**Mack Trucks, Inc.**  
Greensboro, NC USA

**SB-10054060-4103**

Turbocharger Outlet Flex Pipe  
LEU, MRU

## PI0834, Turbocharger Outlet Flex Pipe

W2085297

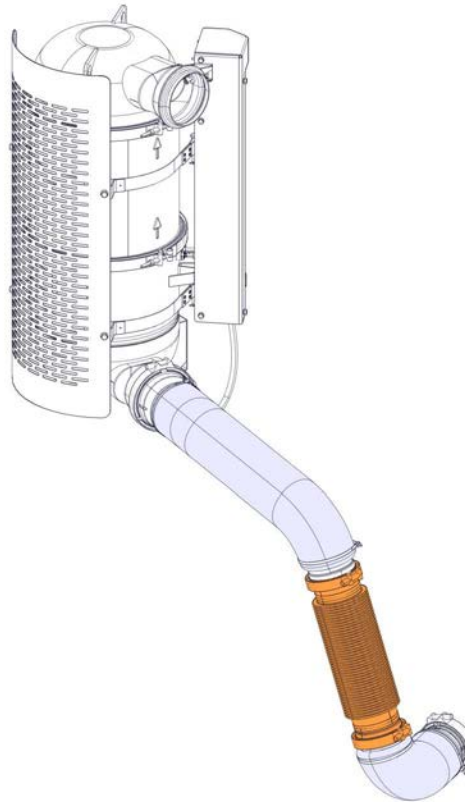
Due to a durability issue with the turbocharger outlet flex pipe, it has been decided to replace the flex pipe on all Mack LEU and MRU vehicles with a MP7 or MP8 engine built between April 1, 2013 and October 13, 2013. Replace flex pipe part number 21959391 with flex pipe part number 21428530.

**Note:** To obtain the optimum life from the pipe, it should be installed straight.

**Note:** Flex pipe **MUST** be installed as straight and parallel to the turbocharger outlet pipe and DPF inlet pipe as possible.

**Note:** Flex pipe should NOT be installed in a curved manor.
